Crail Hill  
 From: Chris Osterrieder [osterrieder@delucahoffman.com]  
 Sent: Tuesday, October 10, 2006 12:48 PM  
 To: Randy Alred; Drew Shiers  
 Cc: Howard@delucahoffman.com; Crail Hill  
 Subject: Revised PR-3  
 Follow Up Flag: Follow up  
 Flag Status: Red

PROJECT: CUSTOM HOUSE SQUARE OFFICE BUILDING  
 SHEET TITLE: ELECTRICAL PLAN  
 CLIENT: OLYMPIA EQUITY INVESTORS, IVB

DRAWN: LECJ DATE: NOV. 2005  
 DESIGNED: CJO SCALE: 1"=10'  
 CHECKED: CJO JOB NO. 2581  
 FILE NAME: 2581-SP  
 SHEET: C-4A

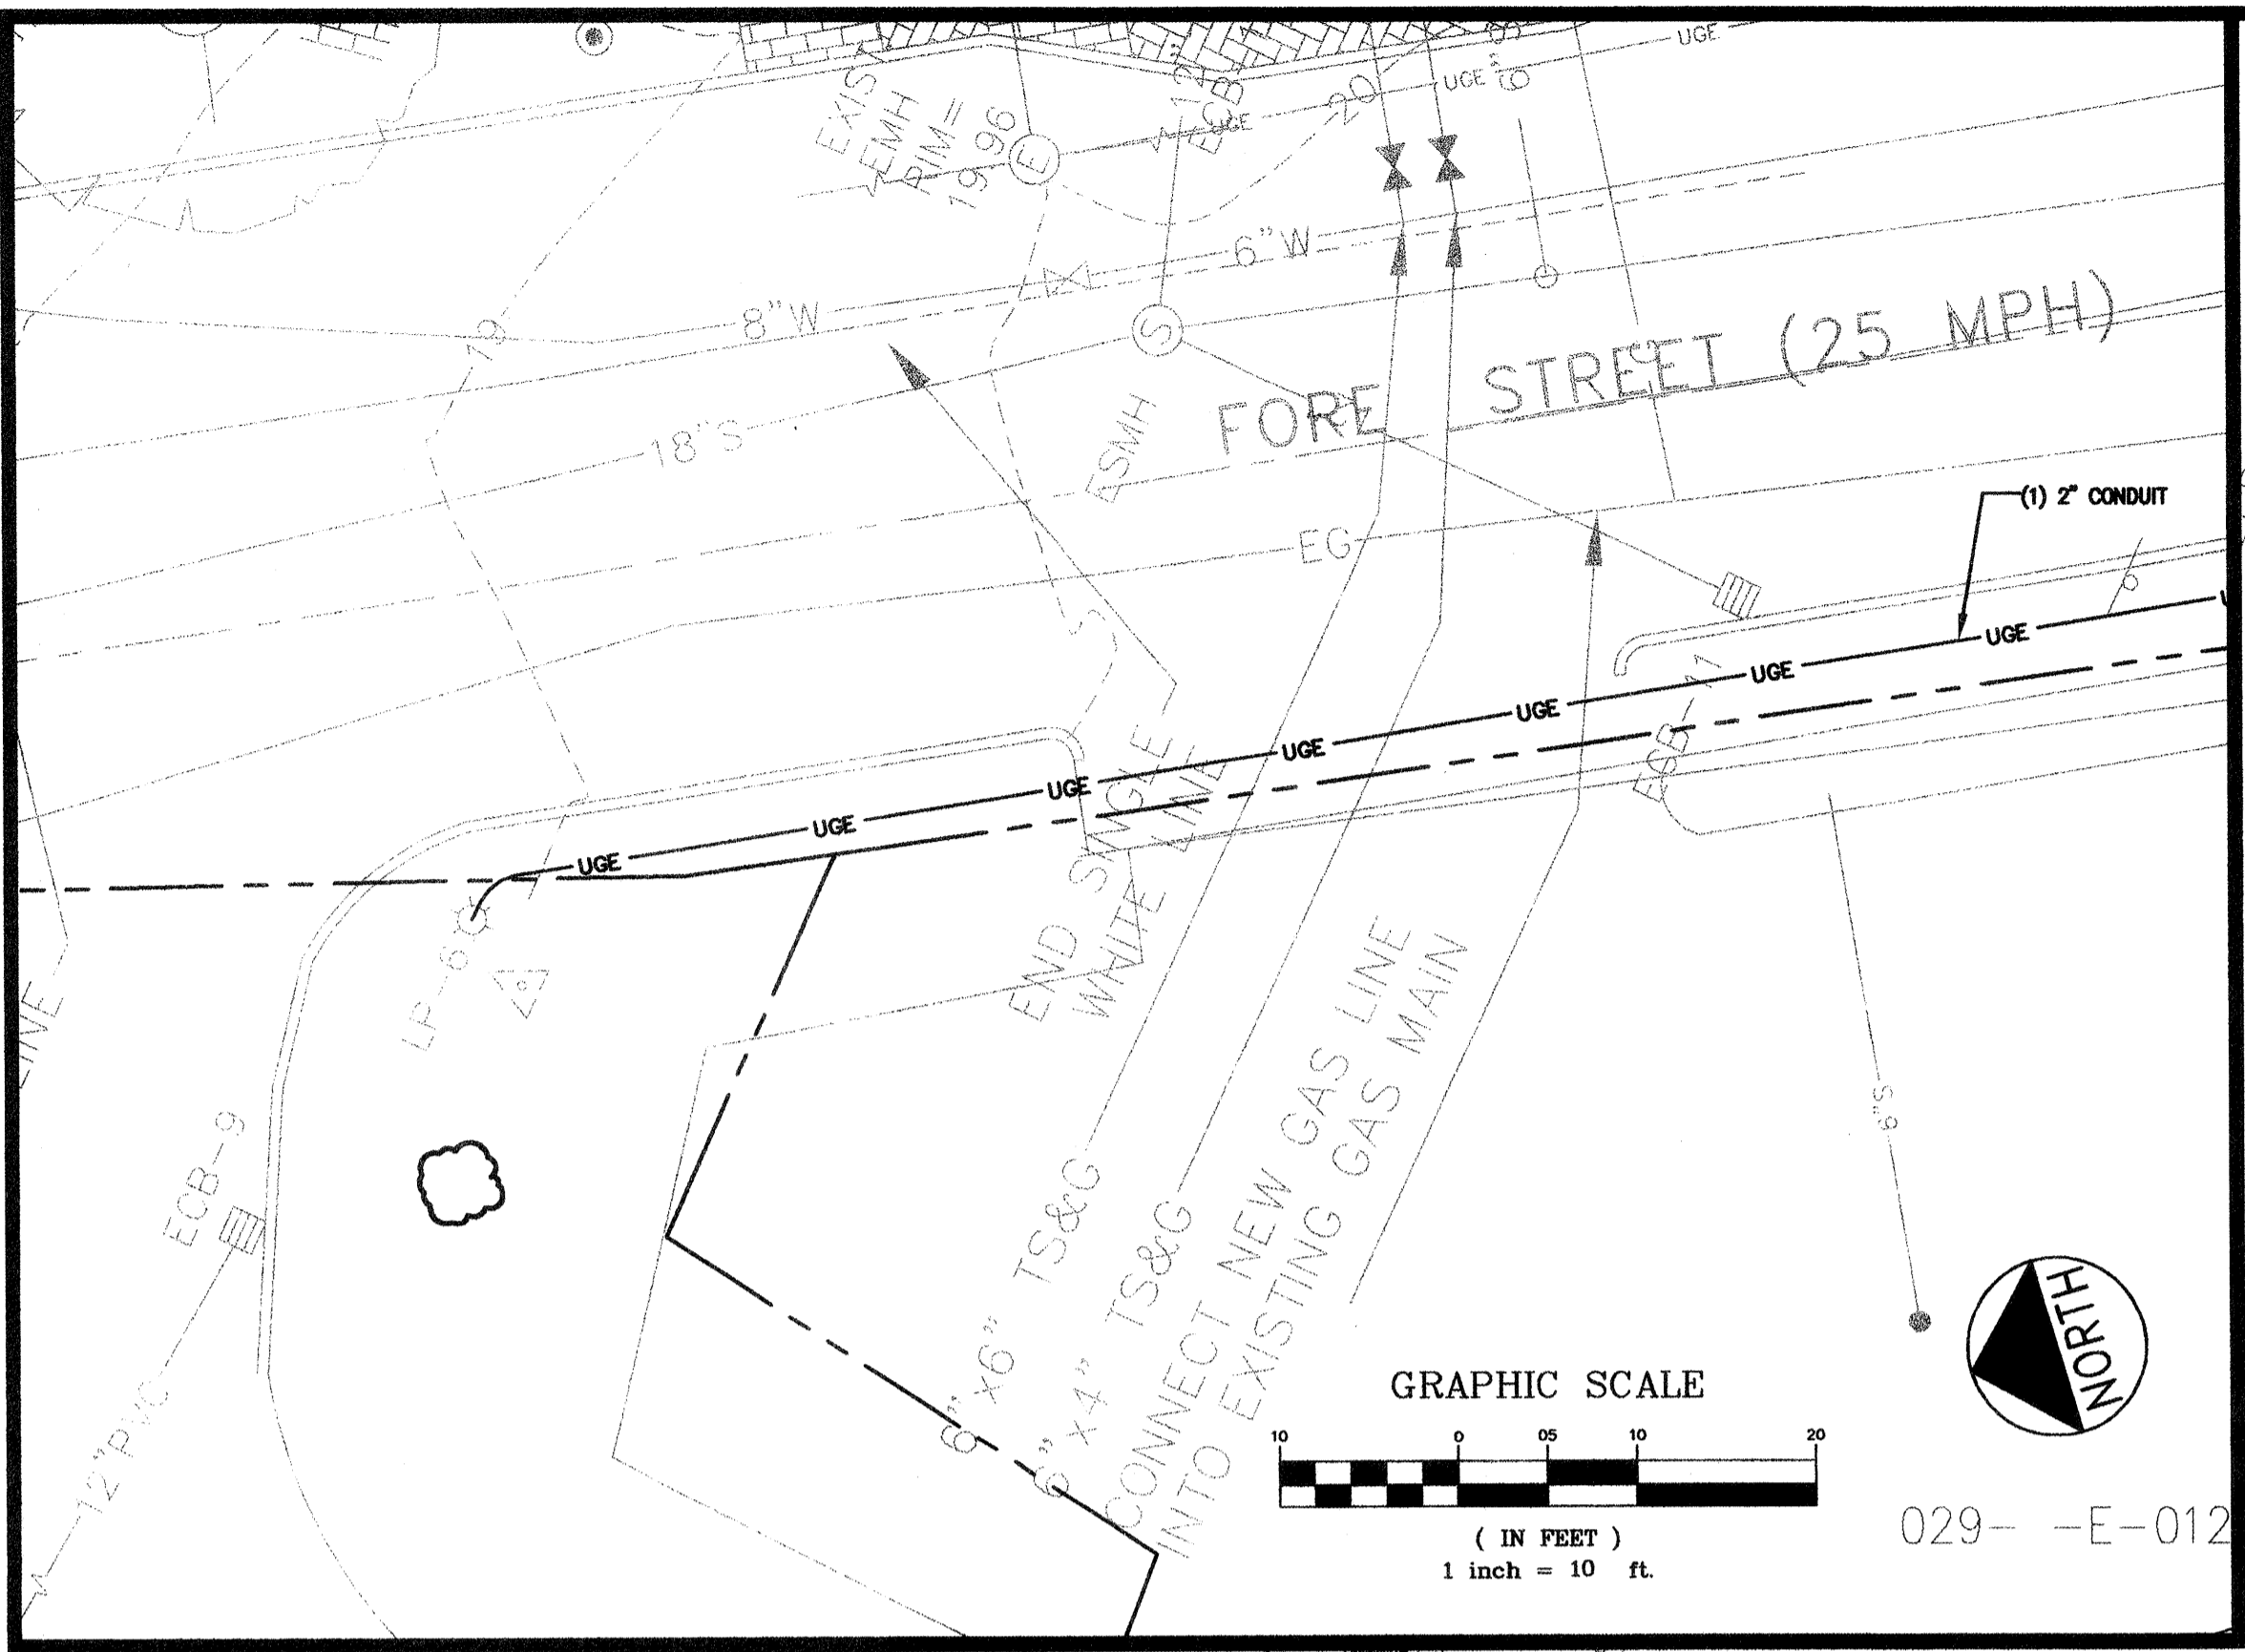
Randy:  
 Attached is a file which should provide you with PR-3, based on meetings with Drew Shiers, CMP and discussions with Drew Shiers. I have revised the plan to provide the necessary detail.  
 A couple key points to understand, considering the plan may not be able to provide the necessary detail:

1. The 4" hand hole at the intersection of Pearl Street and Fore Street (by Casey) has been opened.  
 2. The 4" conduit for cable running down the side of Pearl Street below Commercial Street has been opened.

3. The second 4" conduit crossing the Pearl and Fore Street intersection has been detailed, as well as the location of the conduit through the main entrance in Building 200.

4. The underground conduit (cable and electric) on the main entrance property has been detailed and the work can be completed as needed. Necessary conduits to the site for cable and electric service will be required. Approval of the Map Furniture service remains a requirement.

5. The 4" x 6" conduit that was proposed as a result of the site furniture building to power the Map Furniture is still to be installed from the building. The conduit will be installed from the building to the 100 Middle Street parking garage site. CMP has reviewed the concept and provided a response of the site.

6. The Cable conduits should be run as close to practical as the CMP conduits, per CMP requirements (12" for communication lines).
